PRESTON PLACE & LAKESIDE APARTMENTS

MNCPPC SITE PLAN 820220180

COVER SHEET

SITE PLAN
#820220180

FIRE ACCESS
PLAN

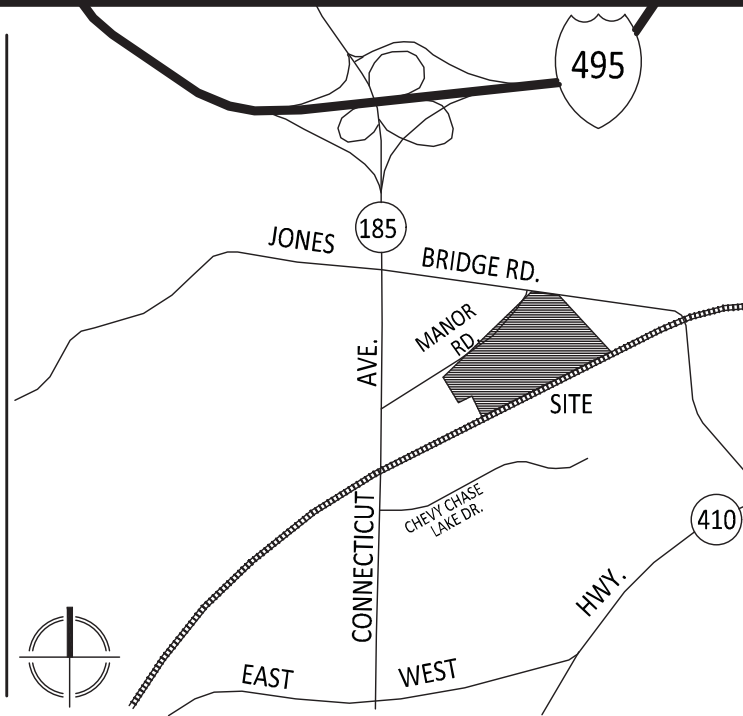
NOTE: SIDE ENTRY ONLY ALLOWED WHERE PORCH IS VISIBLE FROM SAME FIRE DEPARTMENT VEHICULAR ACCESS AS OTHER UNITS IN THE STRING

NOTE: NO DECKS ABOVE 11' HEIGHT ALLOWED ON ALLEY-FACING SIDE.

HEIGHT RESTRICTION DEFINITION:
ONE & TWO-FAMILY DWELLINGS OF 3 STORIES (27'
TO HIGHEST SILL, INCLUDING FALSE DORMERS) OR
LESS MUST PROVIDE ACCESS TO THE OCCUPIED
INTERIOR THROUGH A MAIN, SIDE-HINGE DOOR
WITHIN 150' OF A FIRE DEPARTMENT ACCESS
ROUTE.

*** Height restriction language added ***
